BID ADDENDUM NO. 2

OWNER: EDGEMONT UNION FREE SCHOOL DISTRICT

PROJECT NAME: HIGH SCHOOL BUILDING 'A'
INTERIOR RENOVATIONS

DATE: October 28, 2025

PROJECT: EDGEMONT HIGH SCHOOL BUILDING A RENOVATIONS
300 WHITE OAK LANE SCARSDALE, NY 10583
DRAWING TITLE: CORRIDOR ELEVATIONS

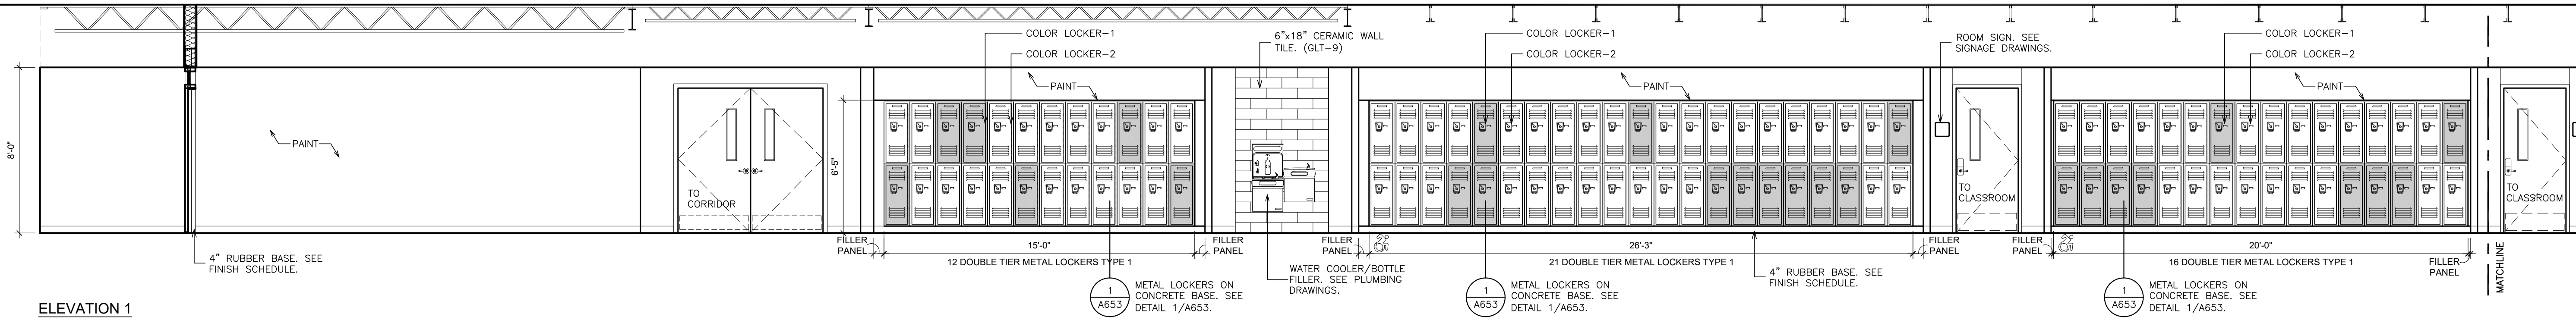
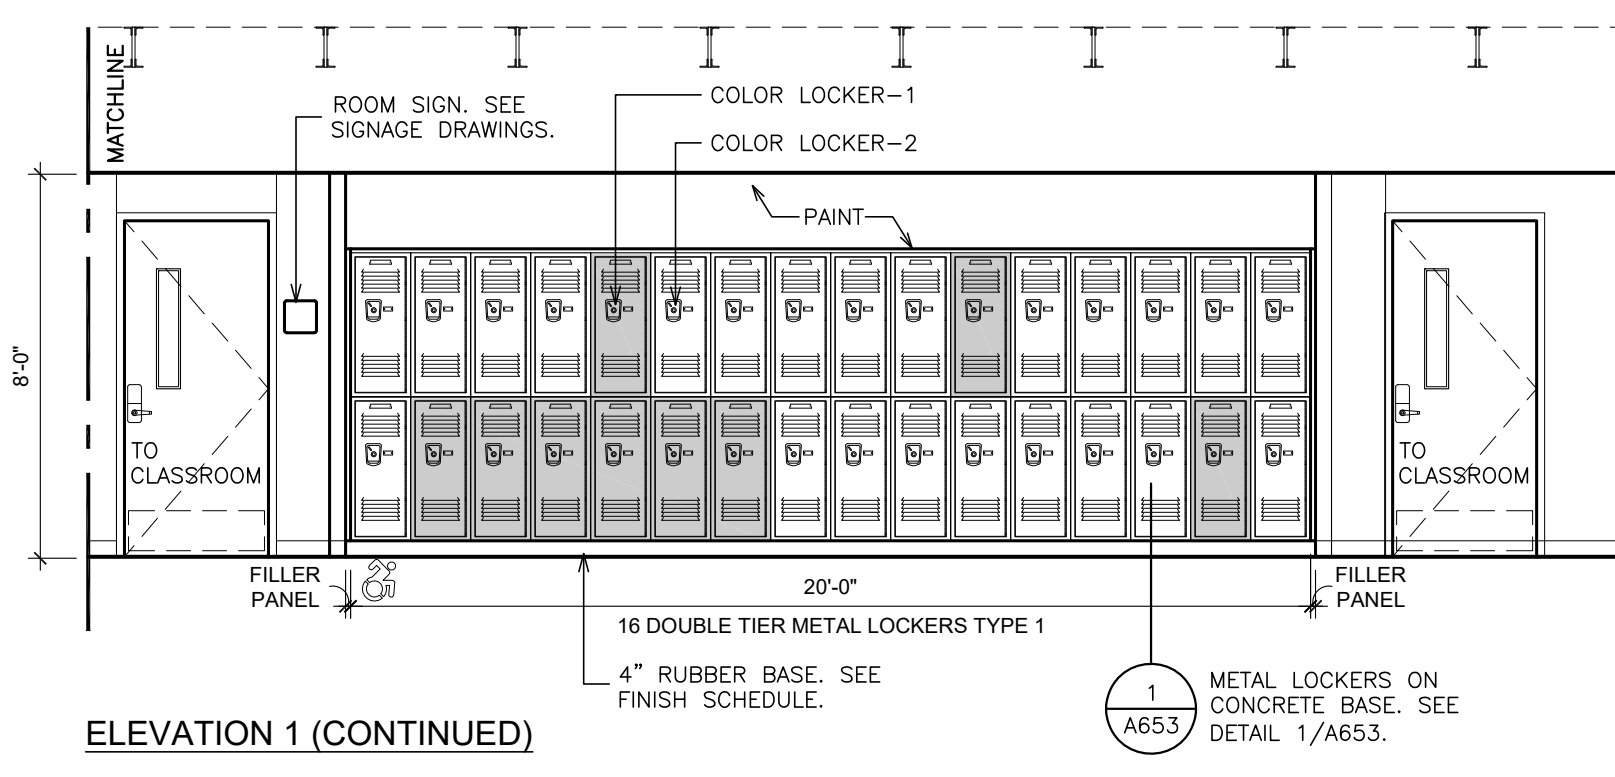
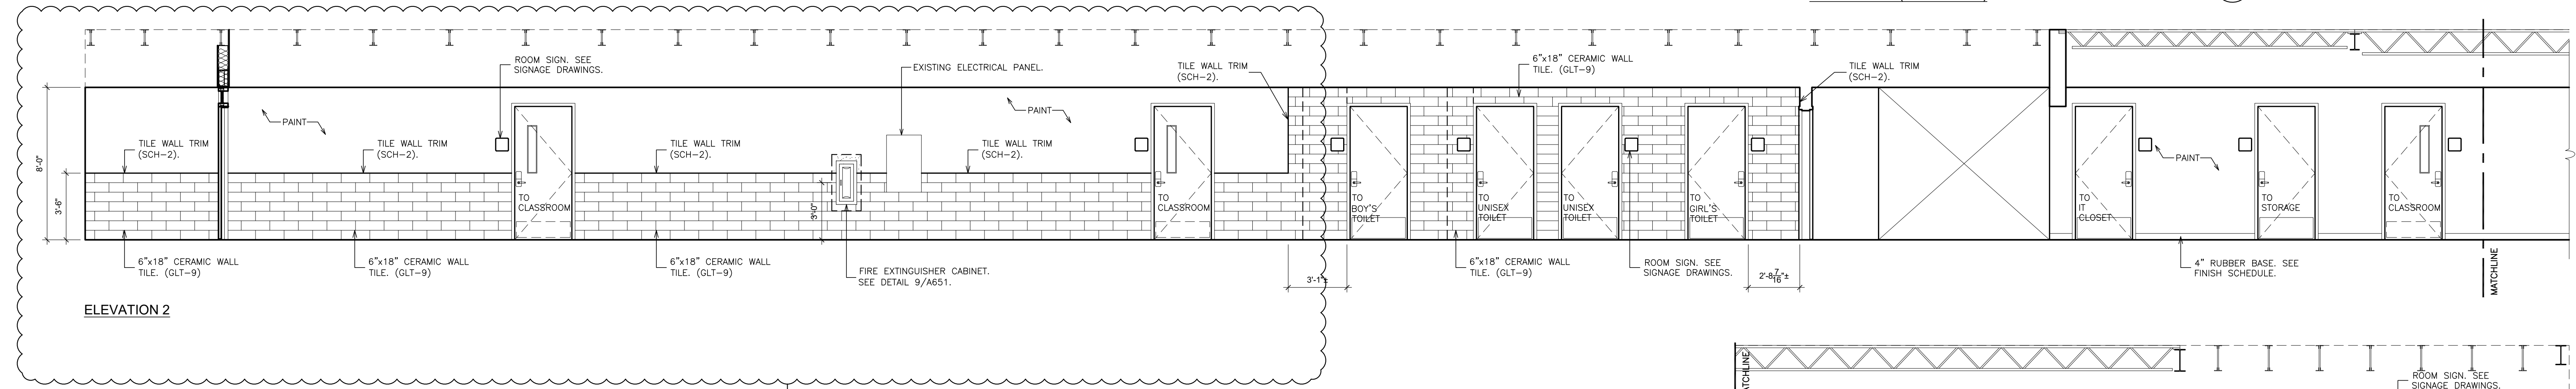
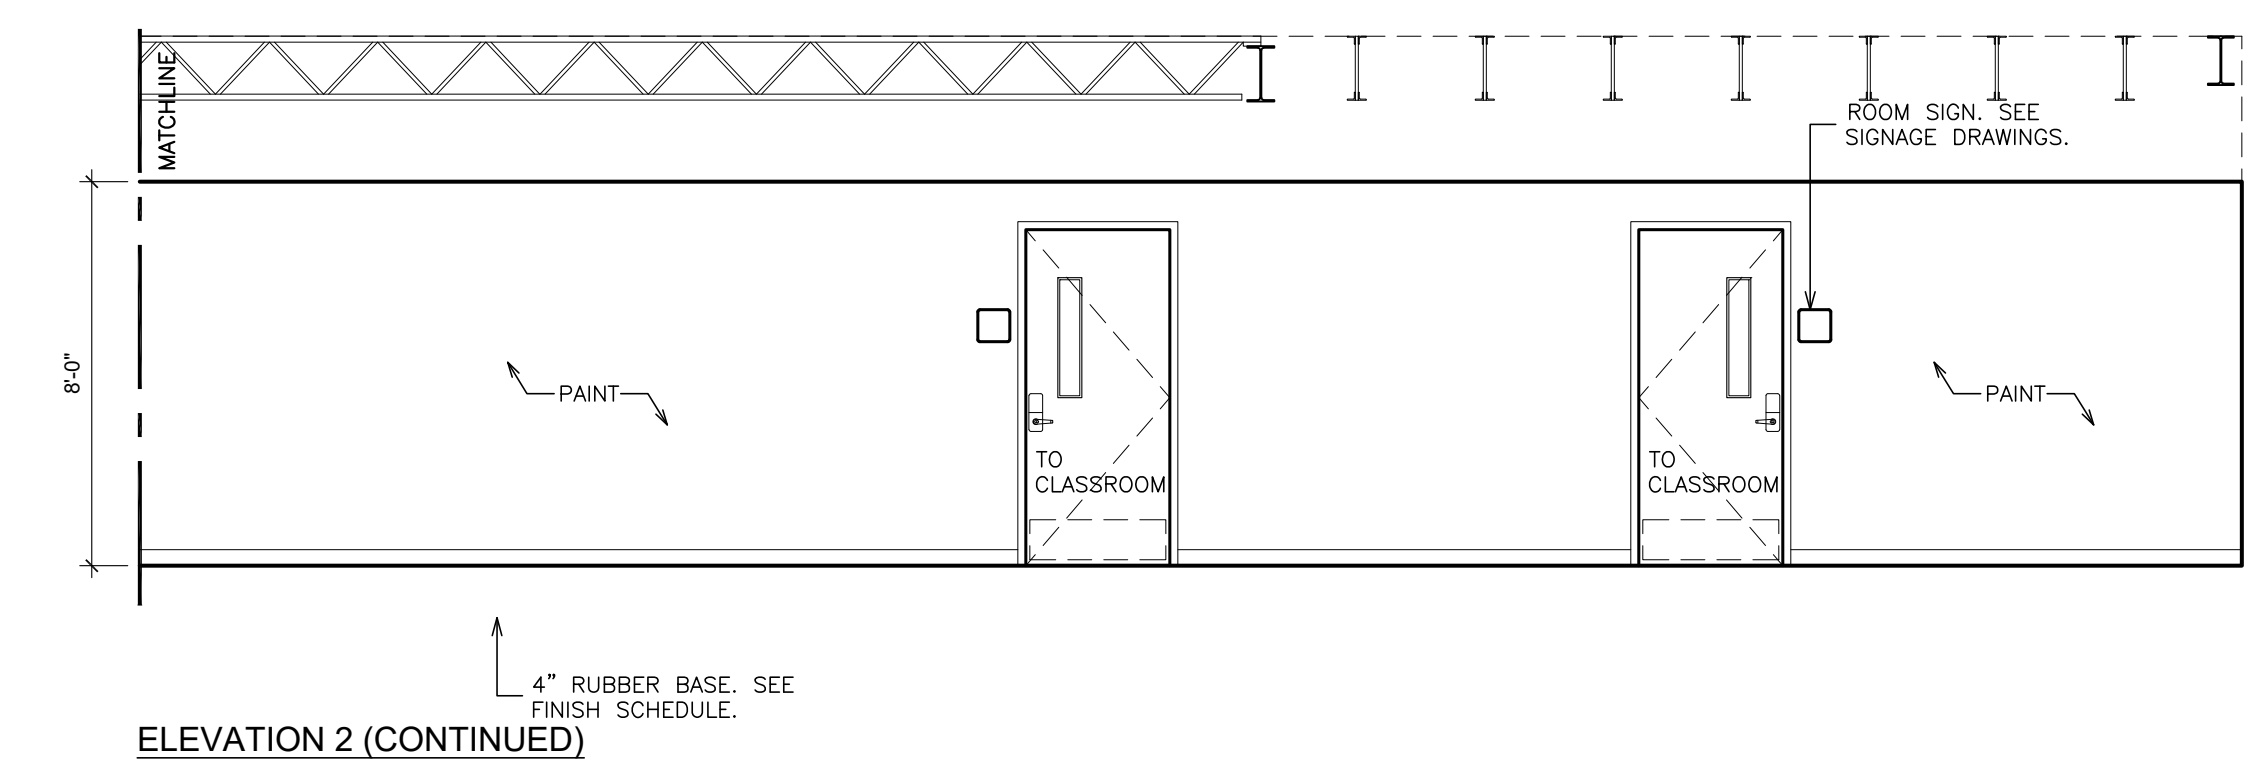
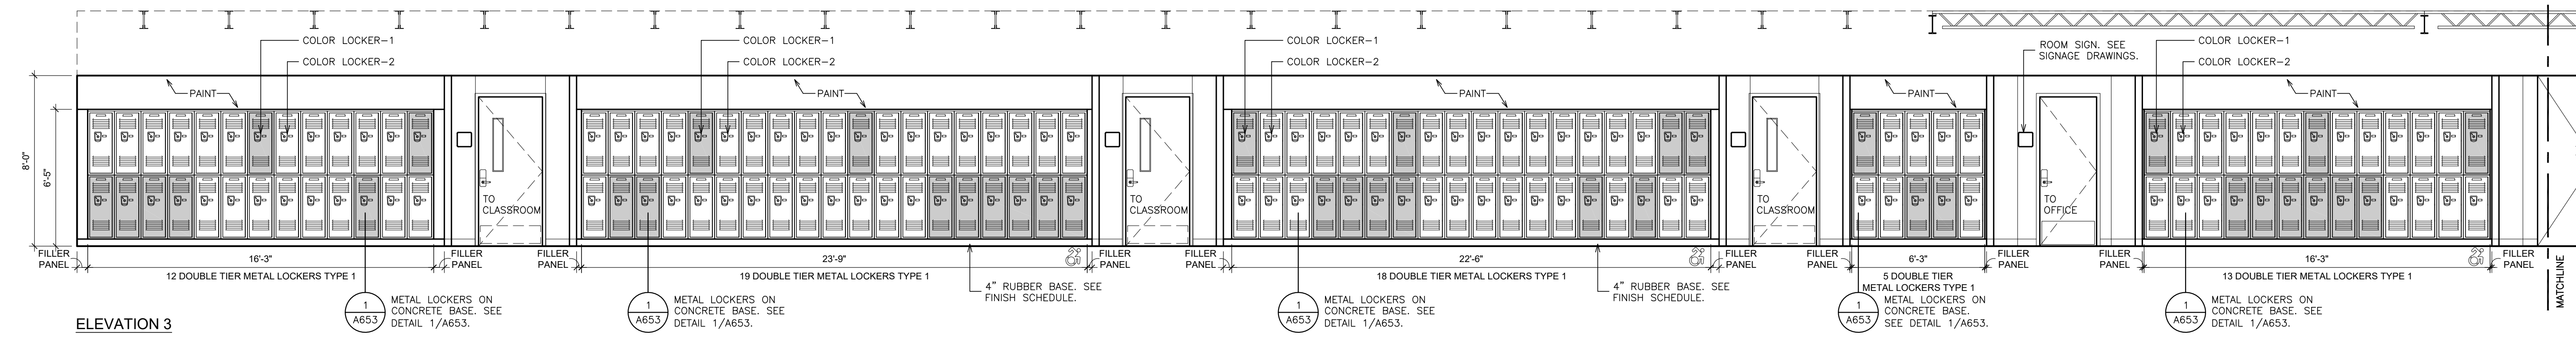
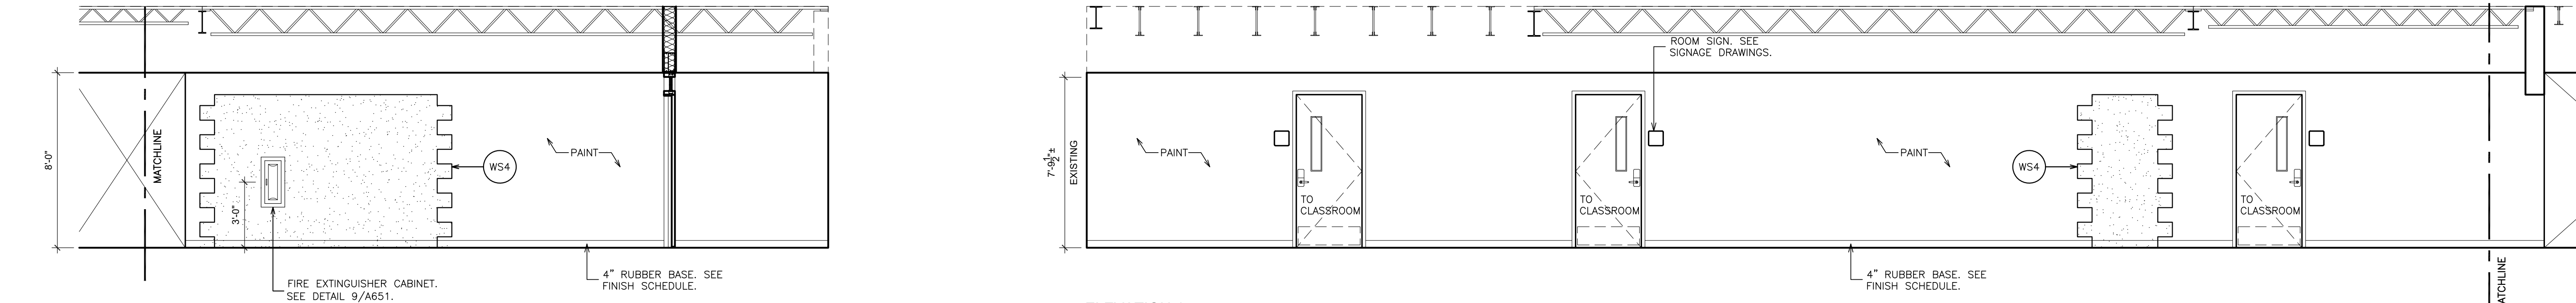
DRAWING A120 – CORRIDOR ELEVATIONS

Detail 1, refinish existing wooden stage and risers as shown on revised drawing attached to this addendum.

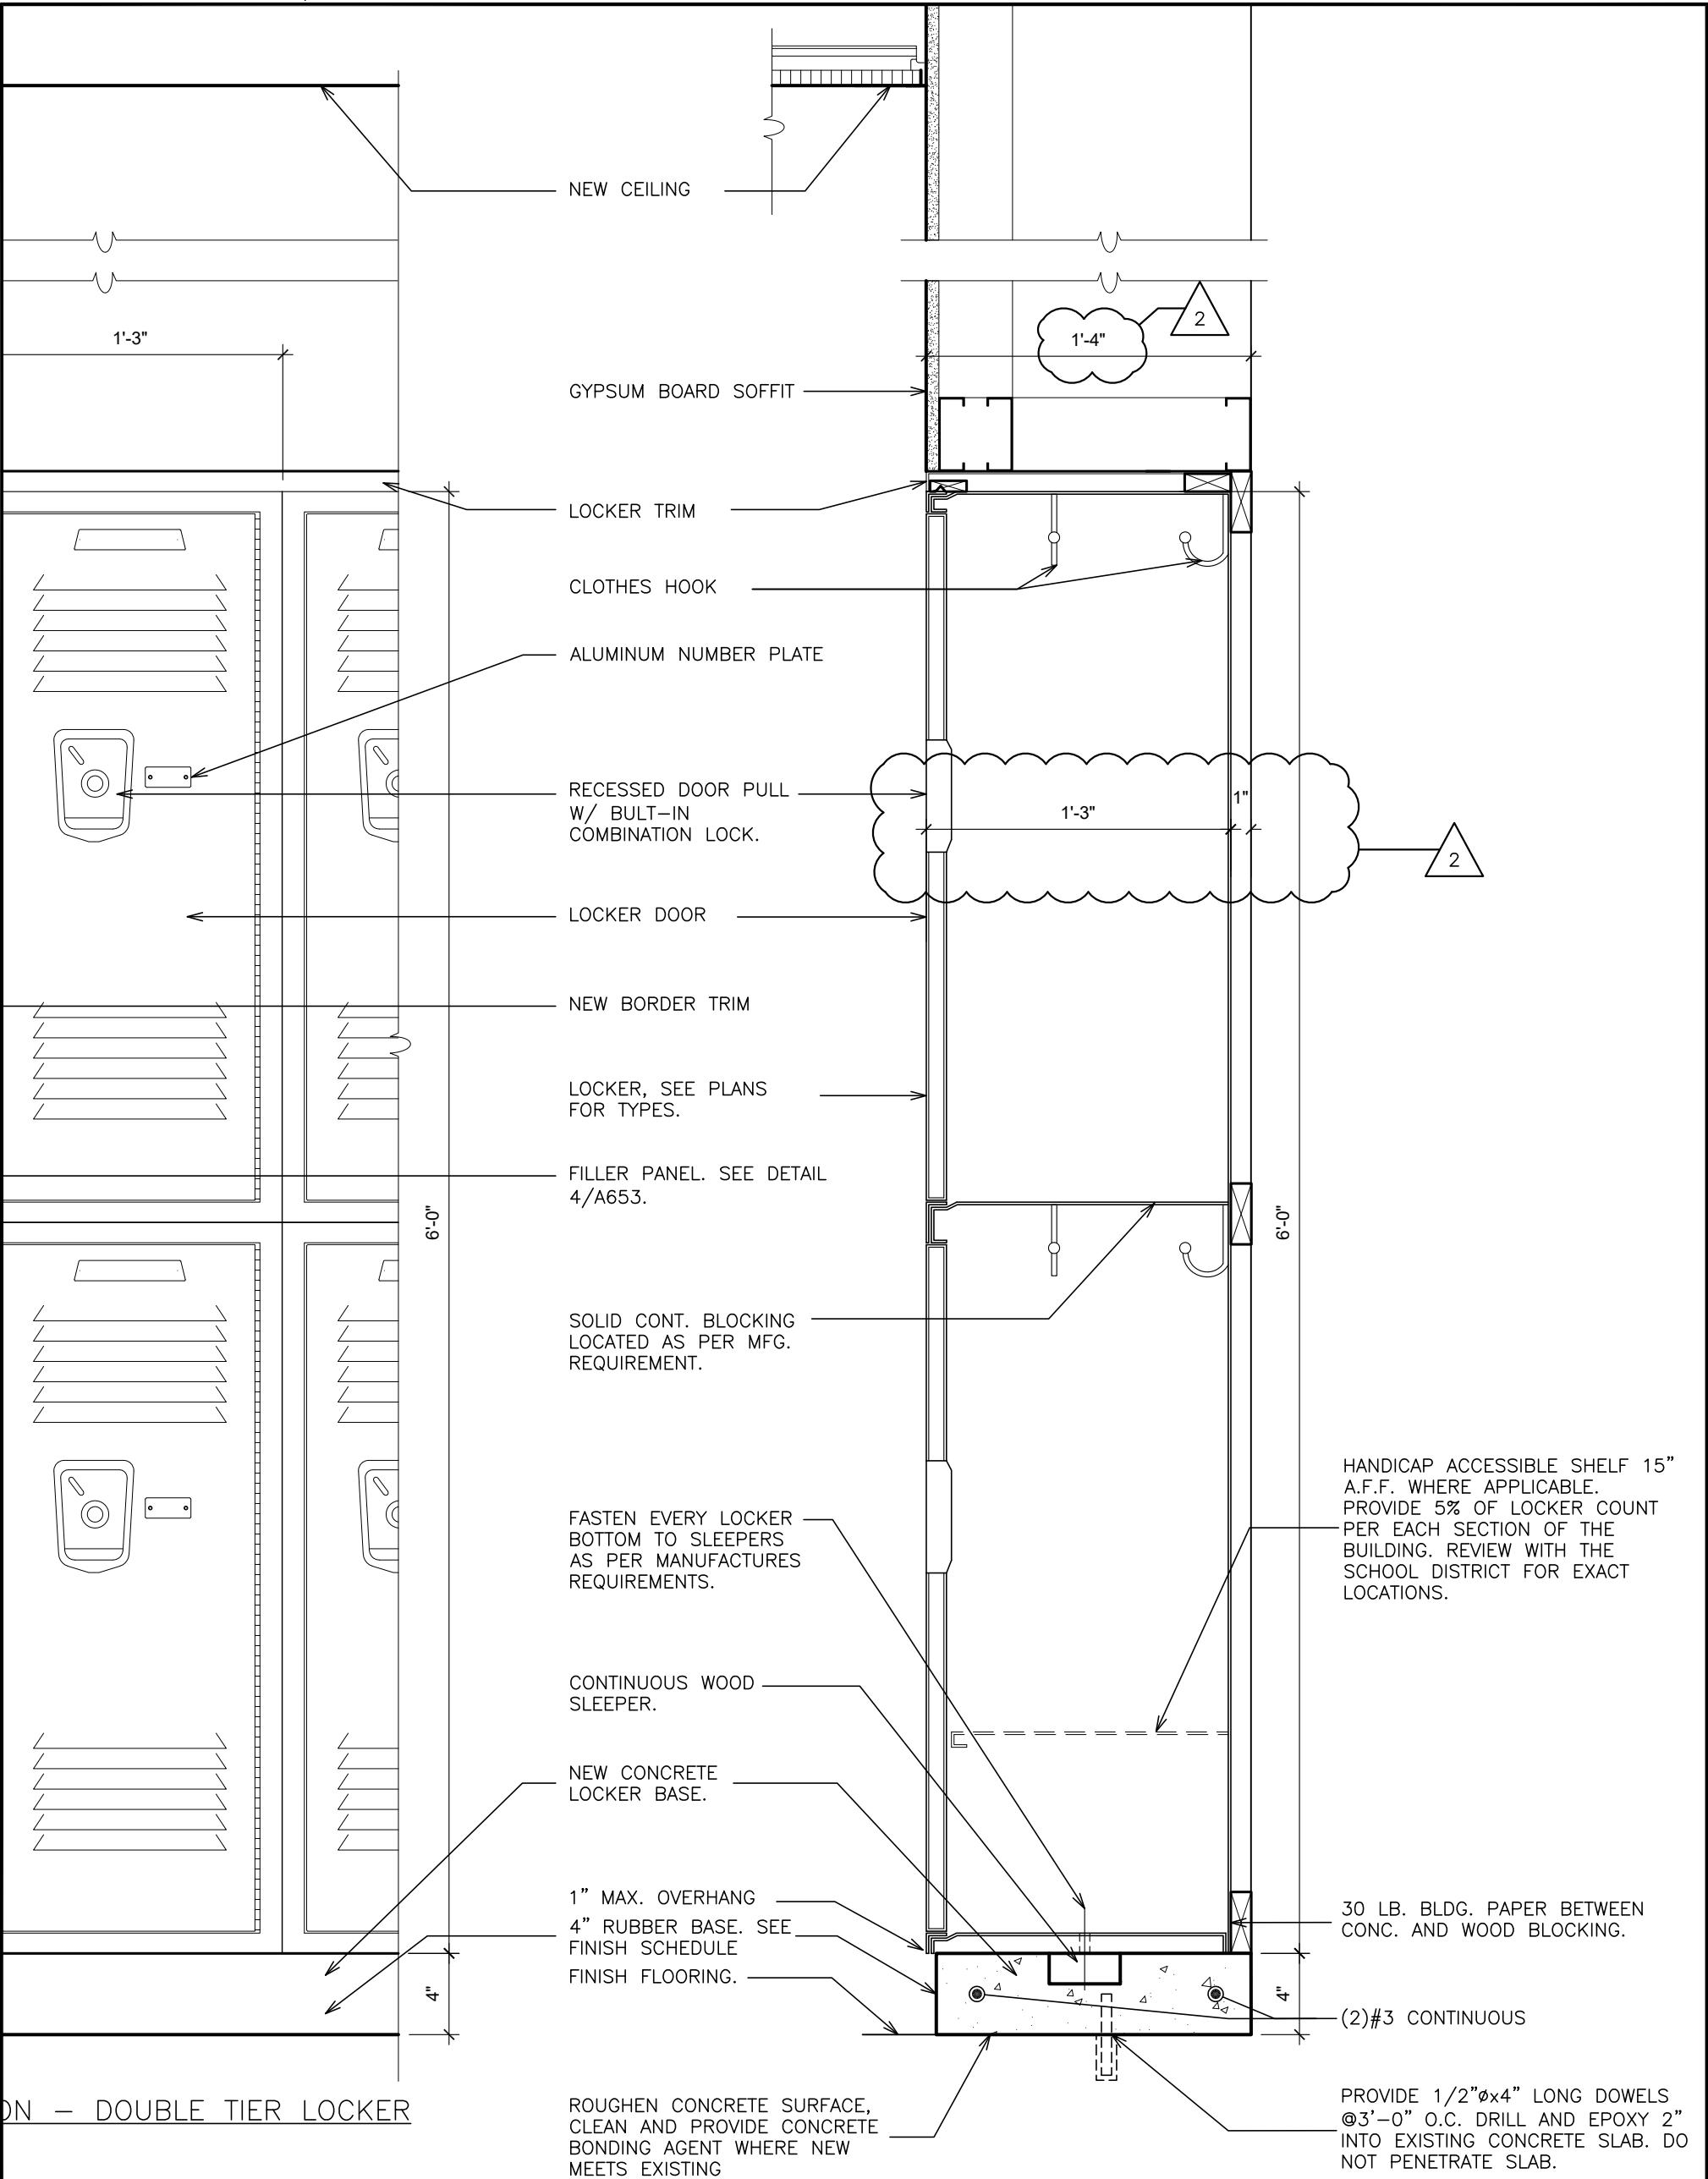
DRAWING A653 – LOCKER ELEVATIONS, SECTION & MISCELLANEOUS DETAILS

DELETE Detail 2.

REVISE Detail 1 for 15” deep lockers as shown on Sketch SK-A1.1 attached to this addendum.
